**Flood Control Project Maintenance  
Levee Inspections**

**Maintenance Issue Types Only, Levee Inspection Report By Mile - Fall 2023**

**Reclamation District No. 0999 Netherlands**

Photo 1 of 1 : FA\_2023\_RD0999\_235\_39\_20231101\_00038.jpg

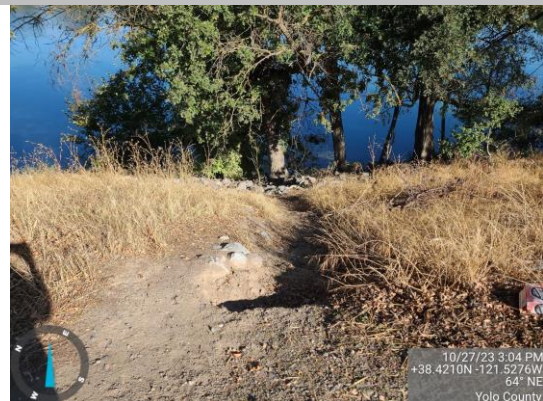
LM Start	0.55	Rating **	M	Issue No.	39
LM End	0.55	Issue Type +	Ma	Location *	WS
Category	Earthen Levee			GPS Latitude/Longitude	
				Start	End
Item	Erosion / Foot Traffic			38.421051°	38.421051°
				-121.527692°	-121.527692°
DWR ID	DWR_RD0999_04_s_2022_39				
Comment Code					
E3 : Repair the levee slope damaged by foot traffic and prevent access where possible.					
Inspector Comment					
Repair two footpaths on the WS slope.

Footpath on the WS slope. Fall 2023
